ENGINEERING CHANGE NOTICE

Originator:	Bo Byoung Jeon	Date:	November 7, 2023	Document Number	ECN20210421-01
	Phone No.:	(416) 754-3322	Part Number	Refer to Table	Drawing Revision
Email Address:	bbjeon@edac.net				
Department	ENGINEERING

Tooling has been worn out. 368 Series Parts have been replaced by 337 Series. Refer to the following left table for the corresponding part numbers. There are minor dimension differences in the following right table(A to D) and alternative part number(337 series) is not pressfit contact.

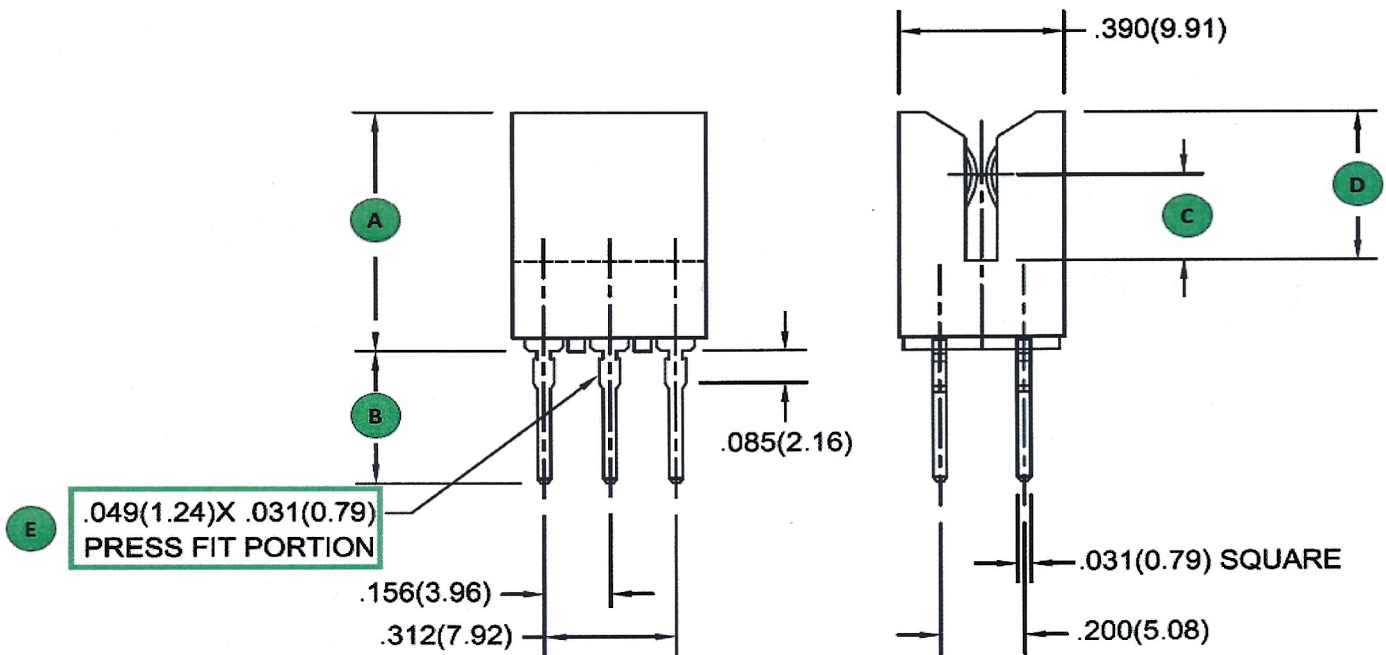
Common Dimension Difference(inch)		
	Obsolete PN	Alternative PN	Diff
A	0.630	0.600	0.030
B	0.380	0.390	-0.010
C	0.230	0.160	0.070
D	0.395	0.330	0.065
E	Pressfit - Yes	Pressfit - No

Obsolete PN	Alternative PN
368-004-520-201	337-004-523-351
368-004-540-201	337-004-542-351
368-006-520-201	337-006-523-351
368-006-520-300	Obsolete
368-006-540-201	337-006-542-351
368-006-620-201	337-006-623-351
368-006-640-201	337-006-642-351
